DEPARTMENT OF TRANSPORTATION

CBA 916-A Foundation for Advanced Education in the Sciences (FAES)

Re: **COMBINED STORMWATER MANAGEMENT
CONCEPT/SITE DEVELOPMENT
STORMWATER MANAGEMENT PLAN** for
F. A. E. S. Social and Academic Center
9101 Old Georgetown Rd.
Special Exception CBA-916
SM File #: 285976
Tract Size/Zone: 1.55 ac/R-60
Total Concept Area: 1.55 ac/ 66,000 sq. ft.
Lots/Block: Contention, Parcel P497
Watershed: Lower Rock Creek, Class I

DATE: 26-Feb-21
TO: Tim Longfellow
Gutschick Little & Weber, PA
FROM: Marie LaBaw
RE: FAES Social & Academic Center
620210100

Combined SWM Concept/Site Development SWM Plan
Accepted
MMF
6/25/2020

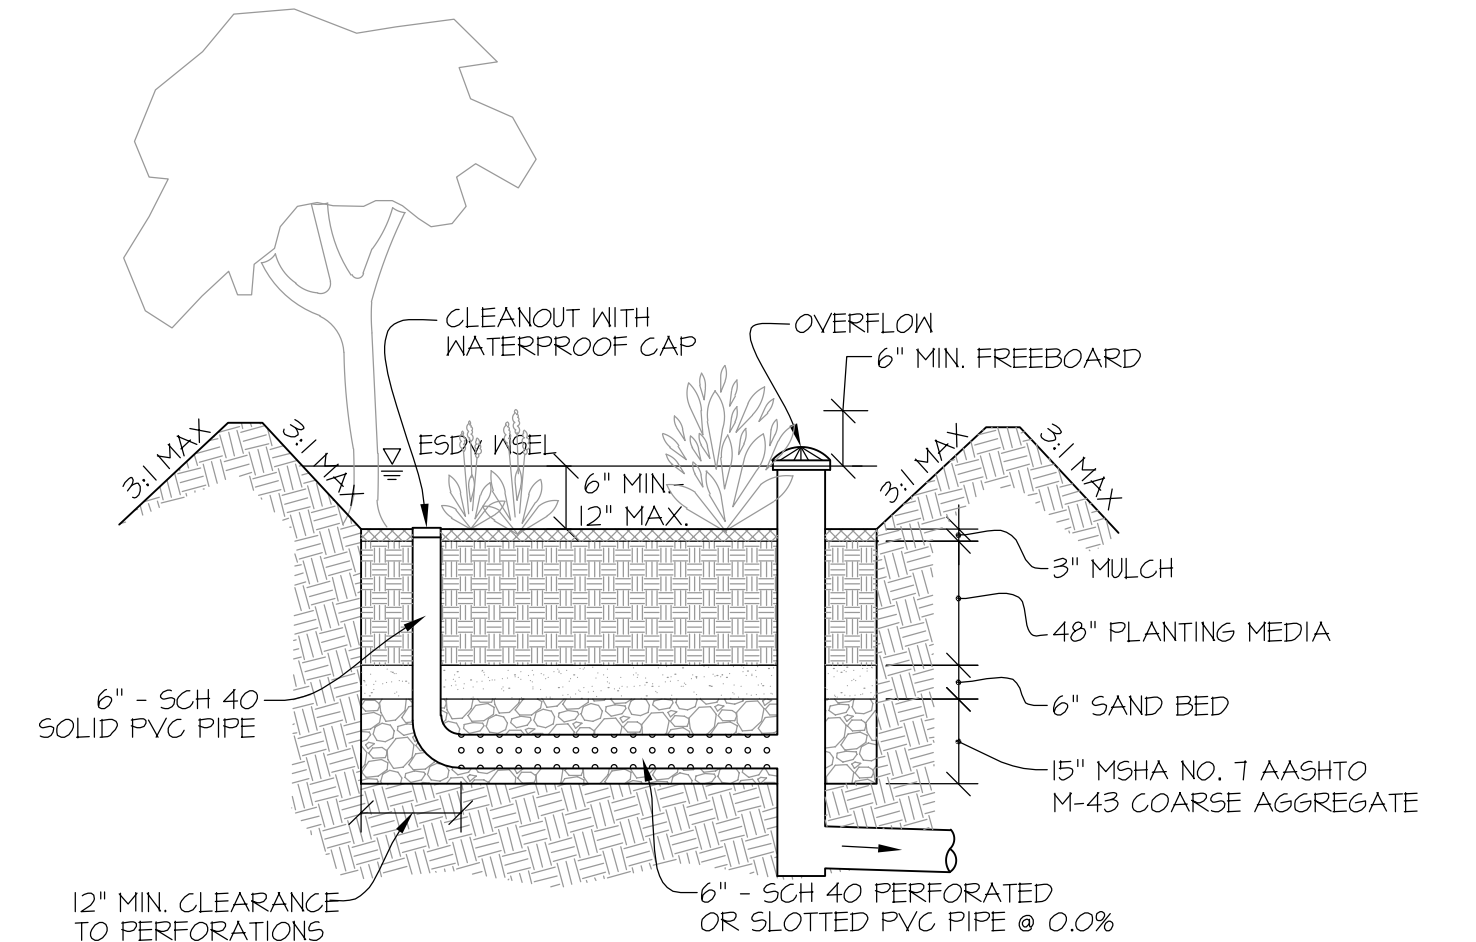
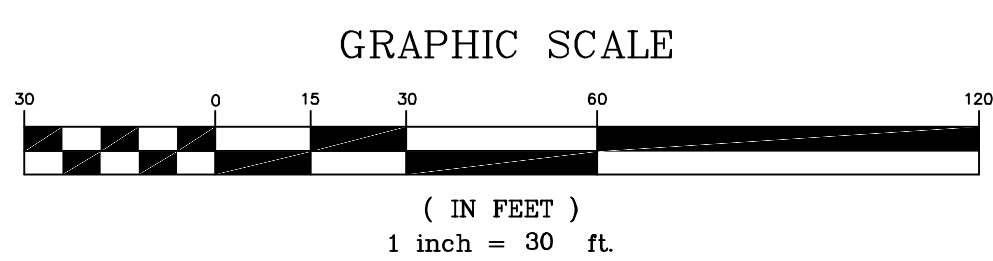
Based on a review by the Department of Permitting Services Review Staff, the stormwater management concept for the above-mentioned site is **acceptable**. The stormwater management concept proposes to meet required stormwater management goals via and Micro-bioretenention.

The following items will need to be addressed during the detailed sediment control/stormwater management plan stage:

1. A detailed review of the stormwater management computations will occur at the time of detailed plan review.
2. An engineered sediment control plan must be submitted for this development.
3. All filtration media for manufactured best management practices, whether for new development or redevelopment, must consist of MDE approved material.
4. All facilities must be designed using latest available MCDPS guidance documents.
